Putts Bridge Project (FERC NO. 10677) - *Moss*

BYPASS WATER QUALITY STUDY PLAN

RE: Putts Bridge Project (FERC # 10677)
Draft Water Quality Monitoring Plan

FIGURE 1

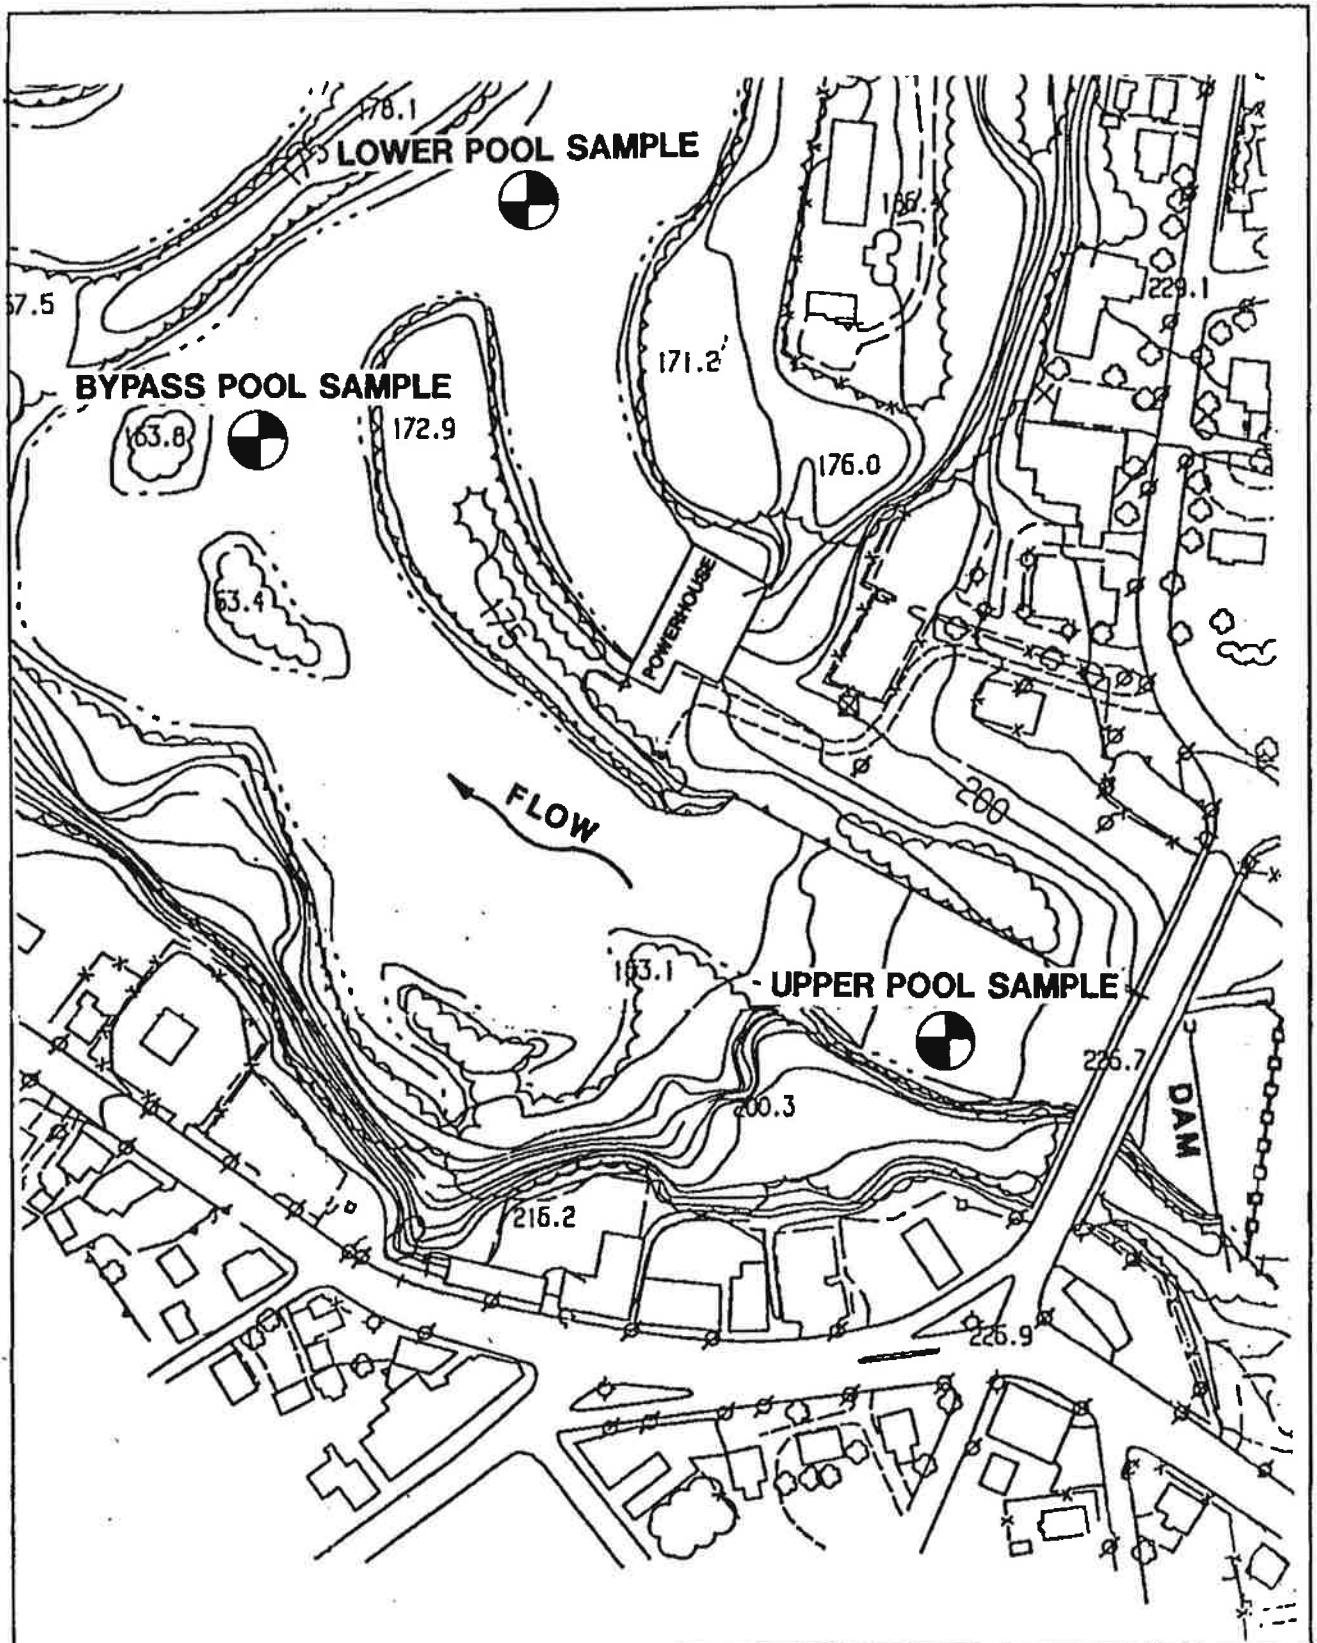
Your proposal to sample the water temperature and dissolved oxygen twice daily during July and August at two locations in the bypass reach and at one location at the confluence of the tailrace is acceptable. We would recommend that the sampling occur at least twice a week in the period July through August, and that the sampling occur during normal summer low flow conditions. Please avoid sampling when the project is spilling into the bypass reach, and provide a summary of bypass reach flow data that corresponds to the water quality sample times.

We have no objection to the proposed study protocol. However, the plan does not specify how many times each week samples will be collected. We recommend that monitoring take place a minimum of twice per week. Also, sampling should take place during the warmest, driest conditions possible (e.g., avoid sampling during or after precipitation events). If higher flows are evaluated, you will need to provide a calculation sheet that verifies how much flow was passed during that monitoring event.

Water quality monitoring will consist of in-situ measurements of DO and temperature collected from the bypassed reach. Sampling will be performed in the deepest portion of pool, at the spillway, and just below the confluence of the tailrace and bypassed reach. (Figure 1). These sites will be sampled twice each week during the months of July and August, 2000 (total of 8 weeks). Sampling events should not occur during consecutive days during the week. Each sampling event will include diurnal collections (morning and evening). Morning samples will be collected within approximately 2 hours after official sunrise and evening sampling will be conducted within approximately 2 hours before official sunset. If depths within the pools at the sampling locations are less than 2 meters deep, DO and temperature measurements will be taken at mid-depth. Otherwise, measurements will be made at vertical 1-meter increments.
